Replacement Instructions for 7027376 HONDA Carburetor Assembly

JLG supplement: 3128938

November, 2004

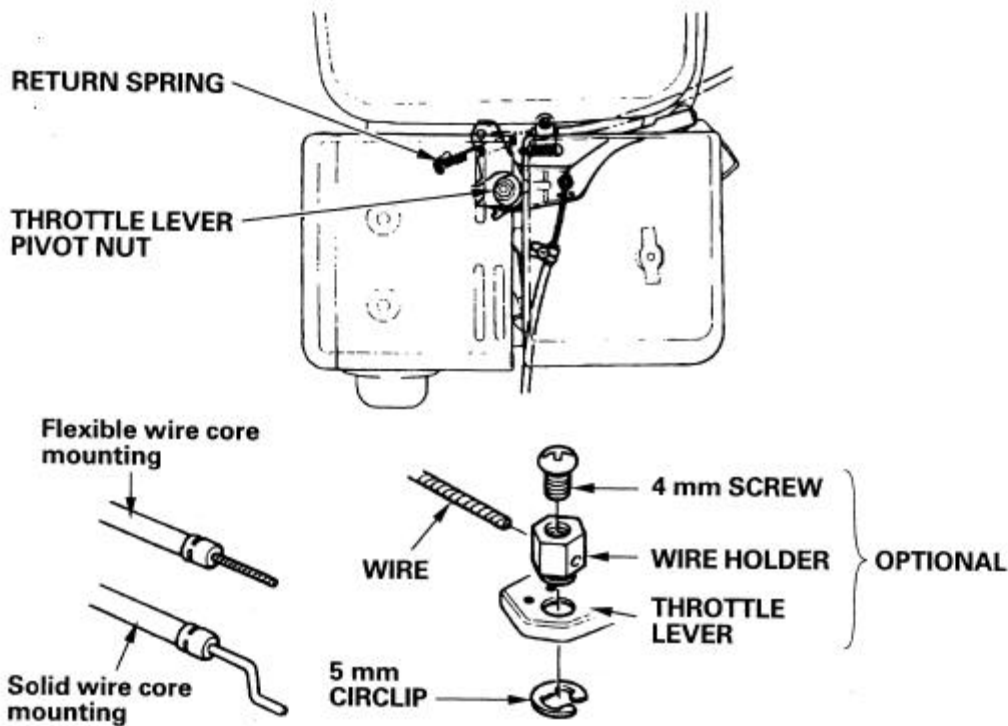
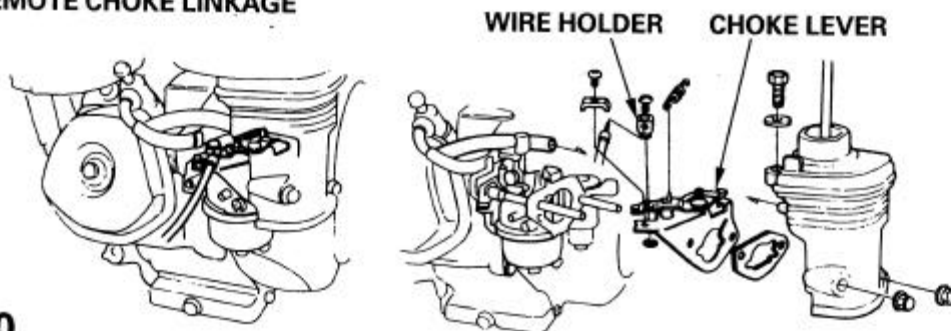
This illustration was taken from the engine Owners Manual that is provided with each engine. Most importantly would be the bottom row of drawings.

ZH90-E1400A

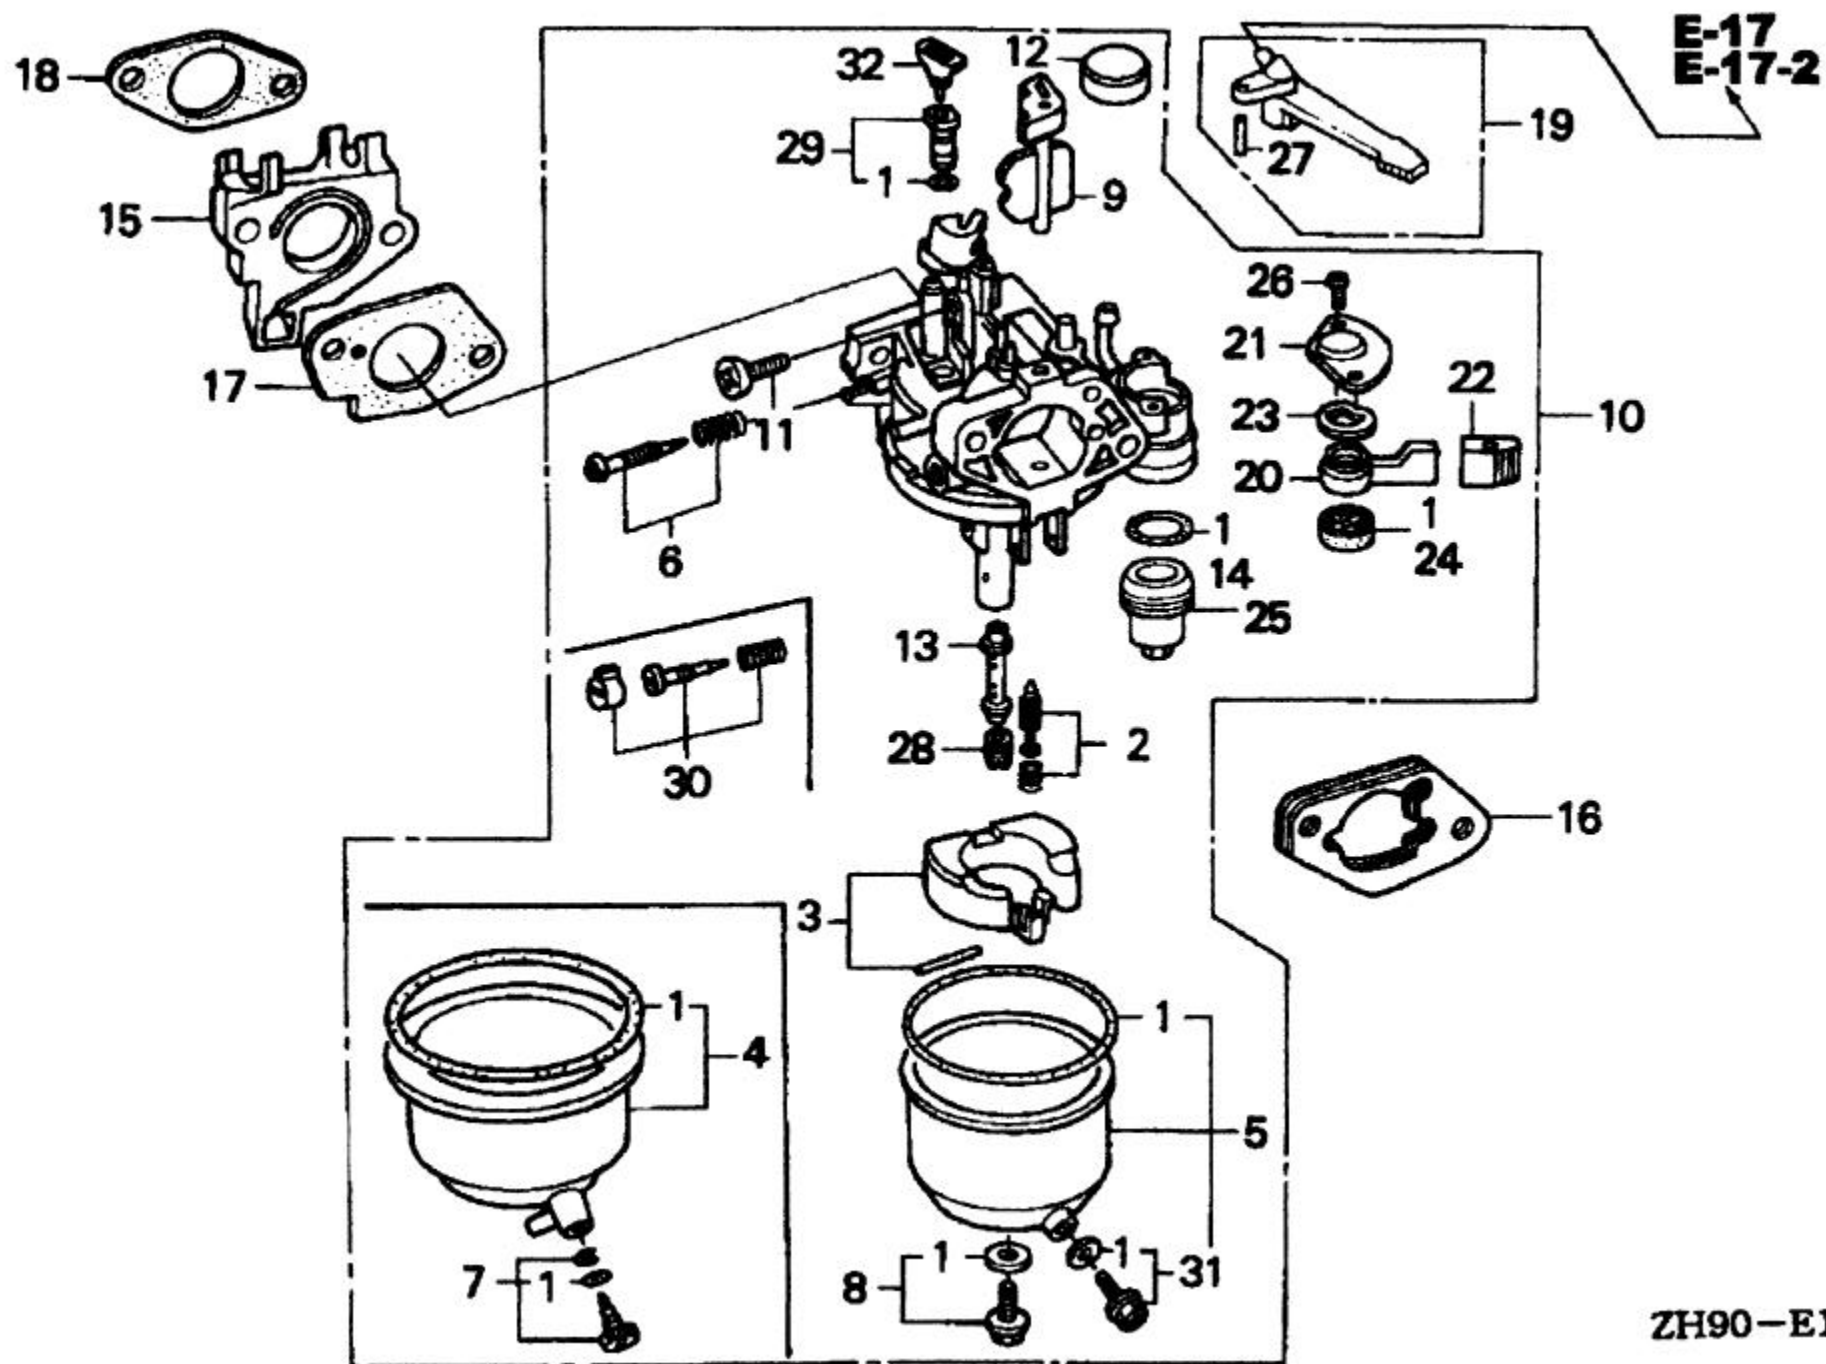
For the carburetor, reference #16 and #19 are **removed** (not used) for the JLG application. Honda part #16590-ZE2-812 (Remote Choke Assembly) is [↩] **added** to the JLG application. An illustration is included on the following page.

To make the Choke Actuator function freely, the choke detent must be removed from a new carburetor.

1. Remove the choke set (reference #9) from the carburetor by carefully opening the slot in the choke shaft enough to remove the choke plate and pull the shaft out the top.
2. Carefully file or grind the choke detent away.
3. Replace the choke shaft and choke plate.
